#2015-63 Crystal Lake South High School
Project Review for Planning and Zoning Commission

Meeting Date: January 20, 2016

Location: 1200 S. McHenry Avenue

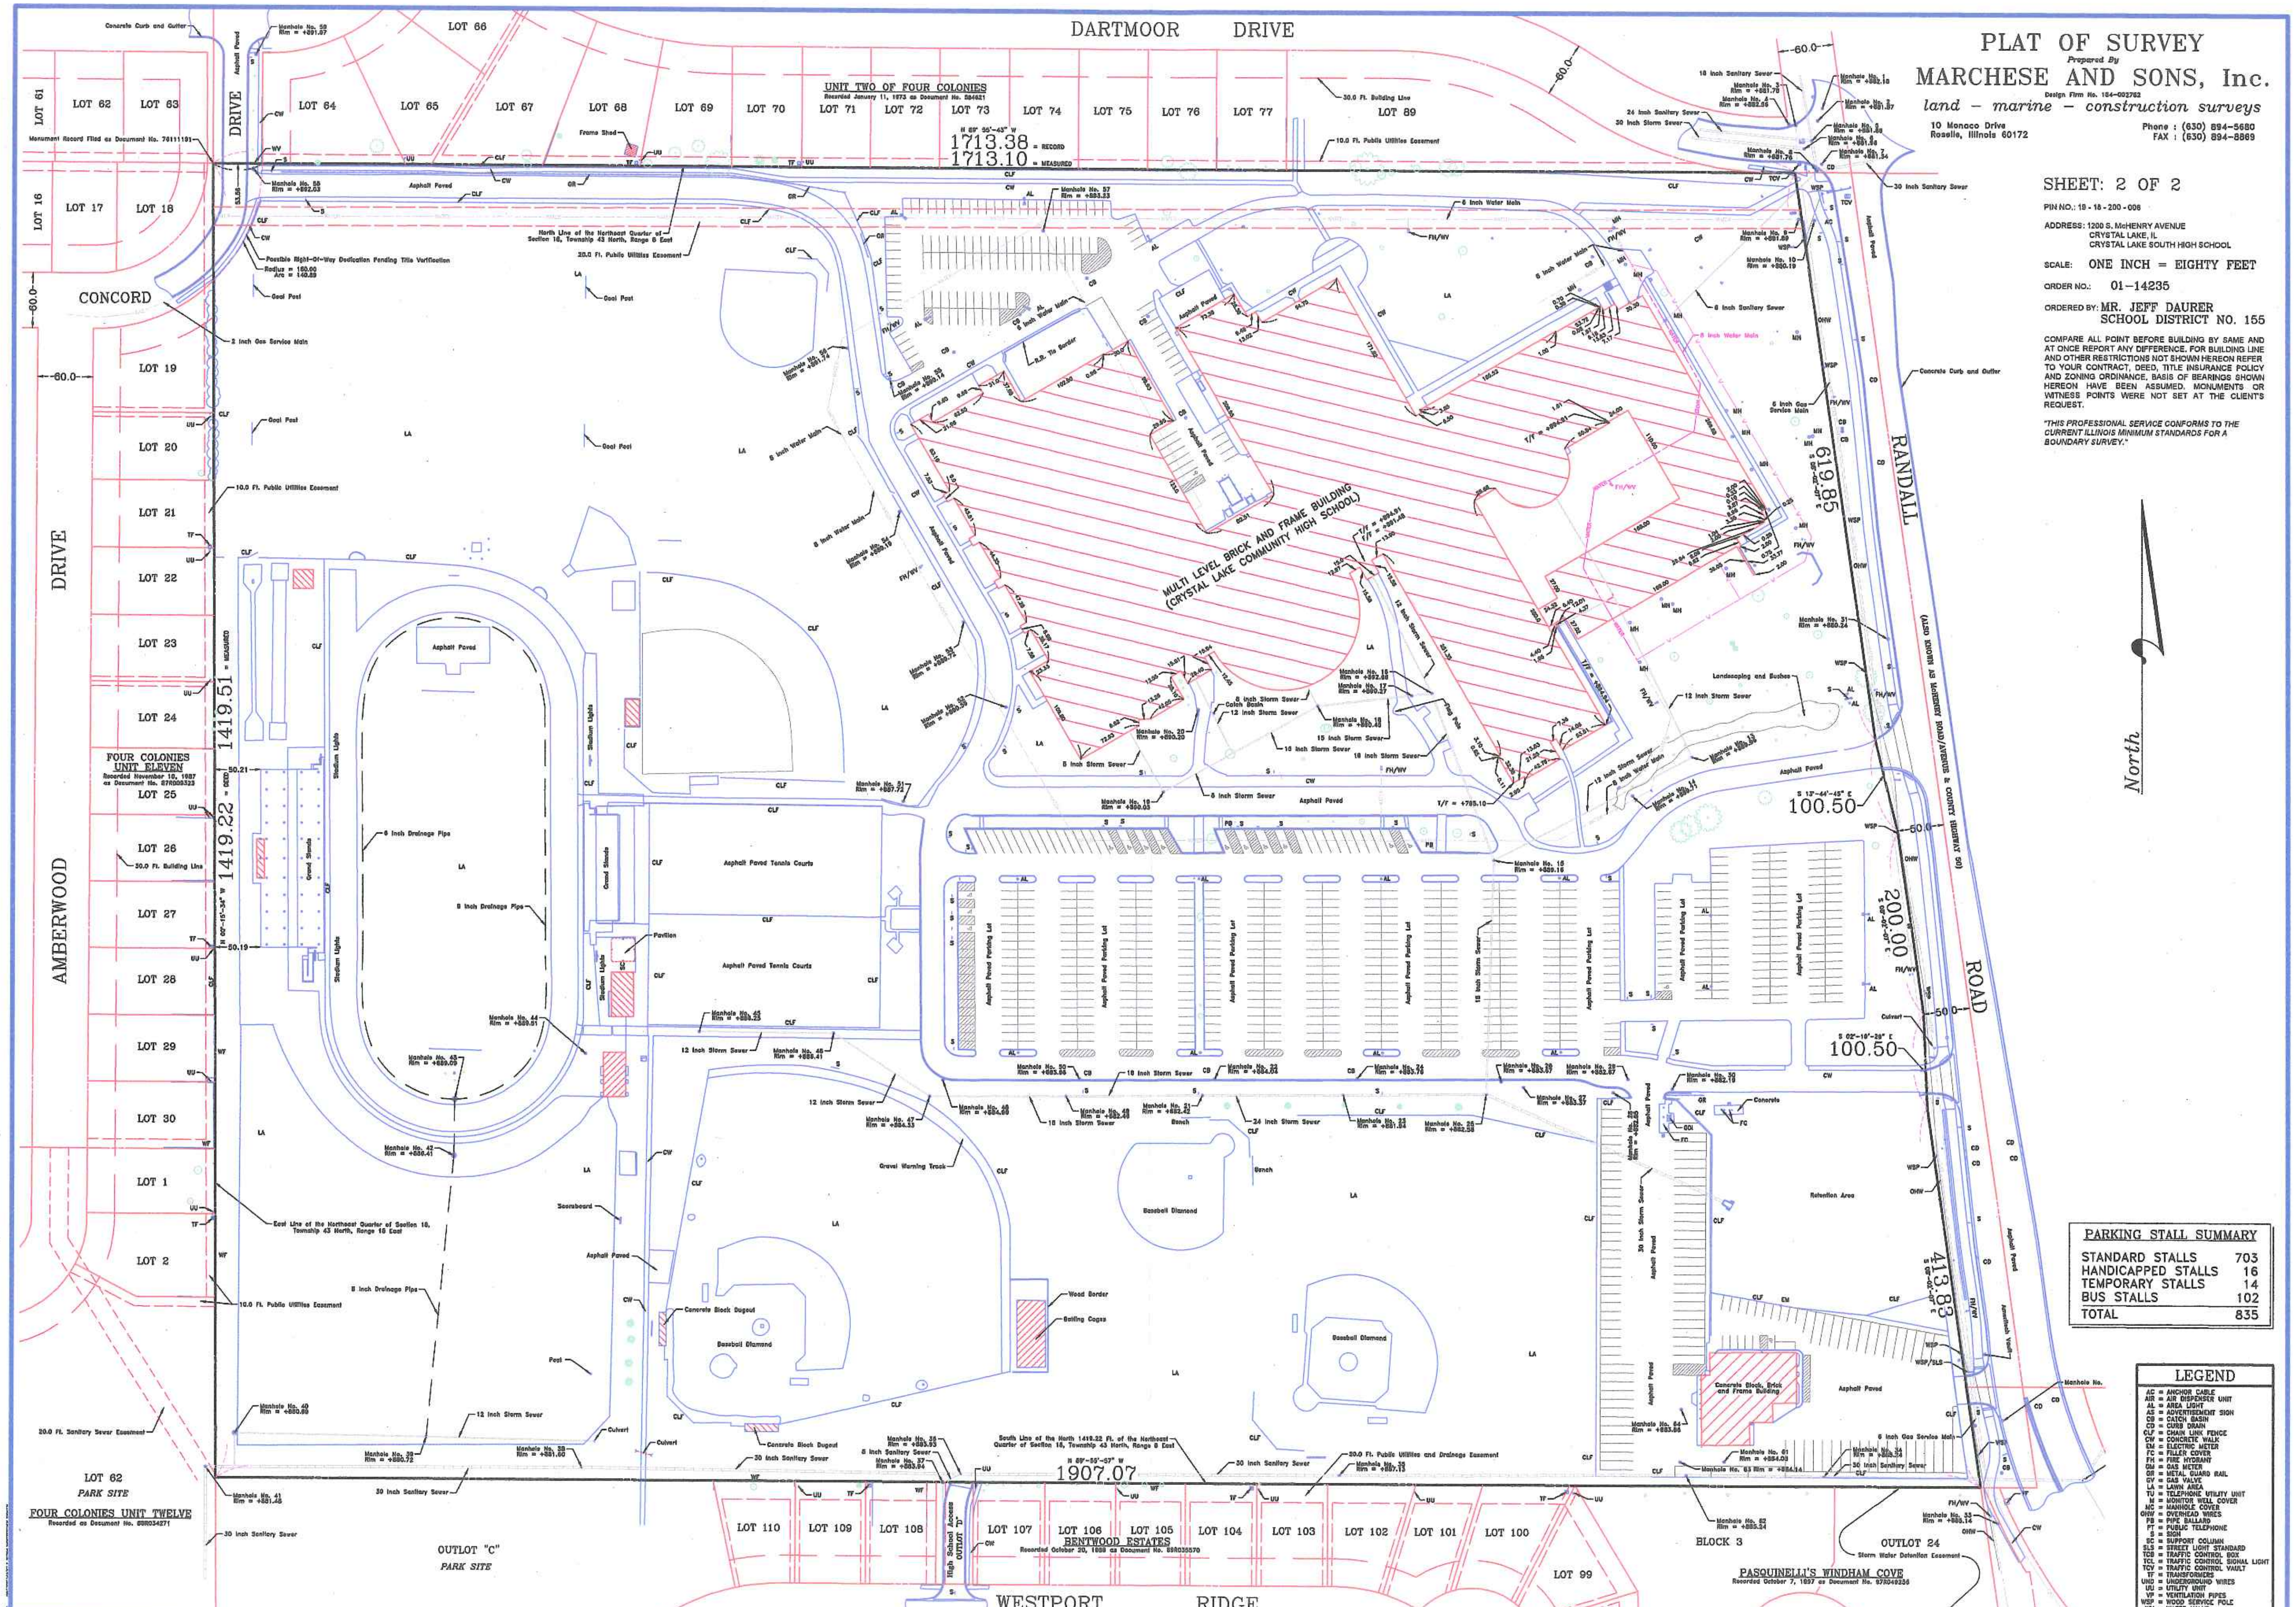
2. Site Plan
   A) The plat of survey at the northwest corner of the site indicates Concord Drive traverses the School District's property. This right-of-way was dedicated with Four Colonies Unit 11 and should be corrected on the survey.

J14 ELEVATION/SECTION - PROPOSED EAST BLEACHERS W/ RELOCATED PRESSBOX & WEST BLEACHERS

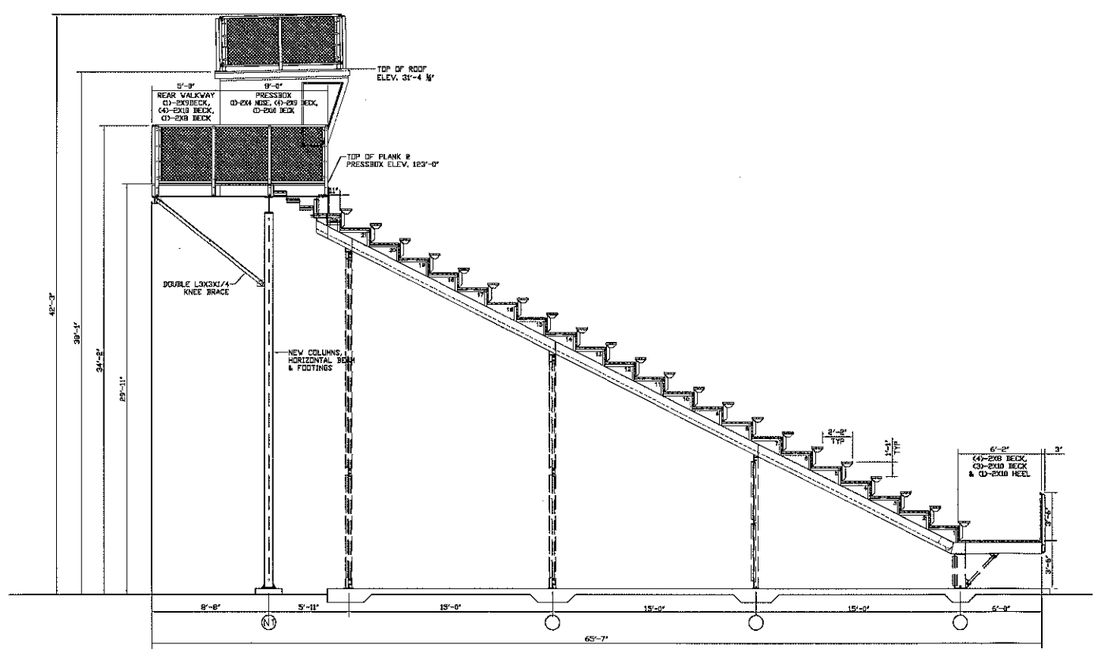
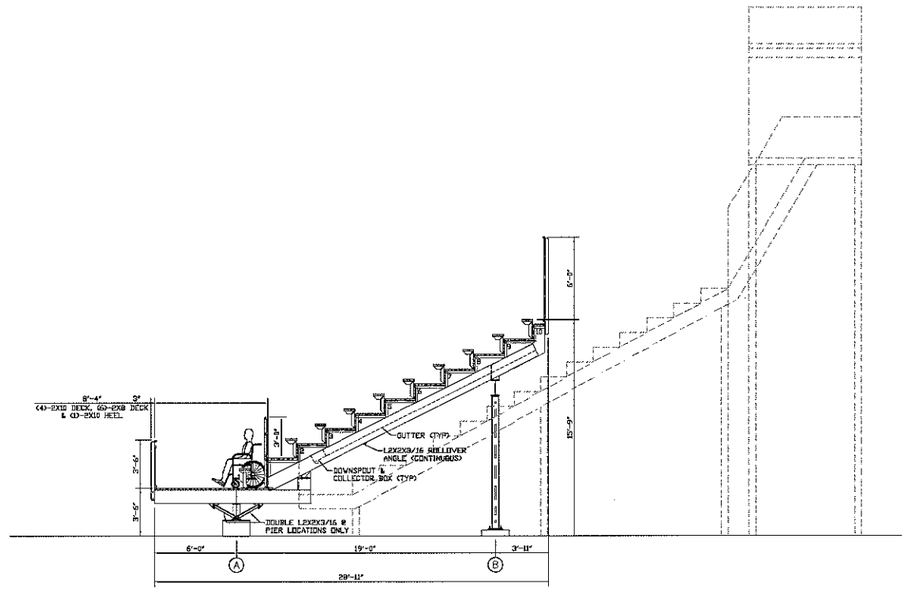
4. Bleachers
   A) The plans do not provide specific details on the screening fence on the west-side bleachers. The west-side bleachers screening fence may be chain-link with neutral colored privacy slat inserts. The final details of all proposed fencing must be submitted for review and approval by staff.

A1 LANDSCAPE PLAN
SCALE: 1" = 30'-0"

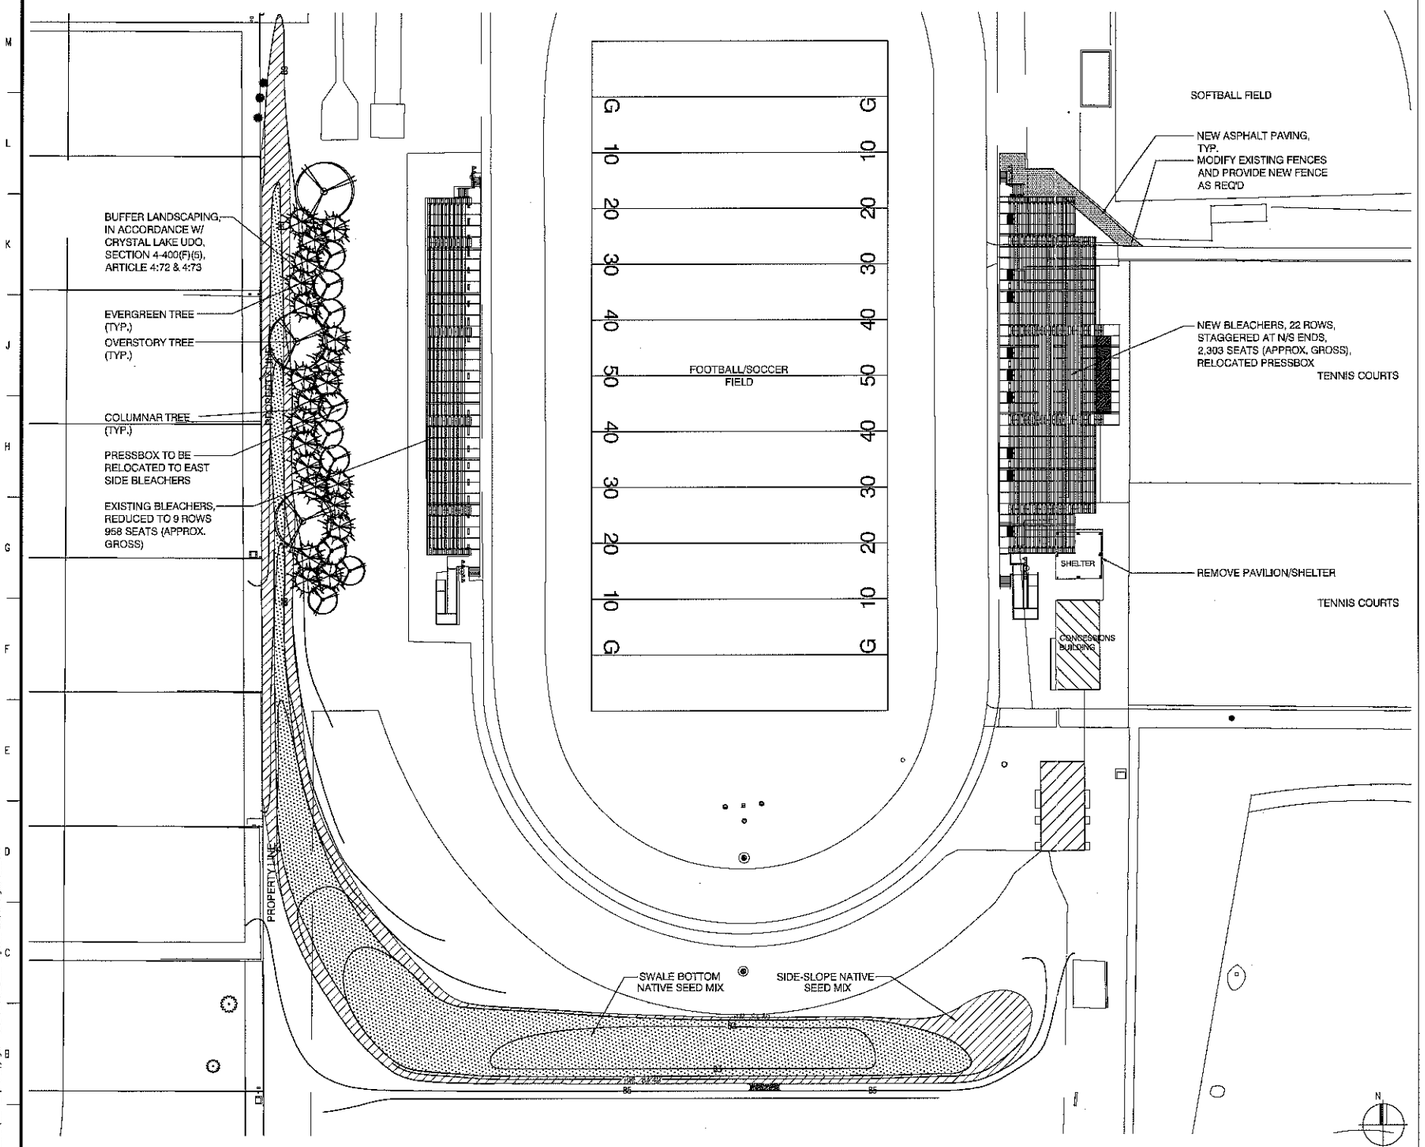
6. Landscape Plan
   A) Indicate the location of the existing chain link fence west of the football field and its relation to the proposed landscape screen. It may be beneficial to keep the existing fence in place and located the proposed landscaping as close to the fence as practical on the east side, allowing for more room for stormwater conveyance to the west.
   B) Extend a landscape screening material for the single family homes to the north and south to completely screen the west-side bleachers.
   C) The landscape screening material must be planted as soon as practical to establish the plants early and maintained as long as the bleachers are present. Provide a maintenance plan for the landscape screen to the City.
   D) Substitute the proposed grasses shown in the area along the rear yards of the single family homes for a more maintainable vegetated cover.
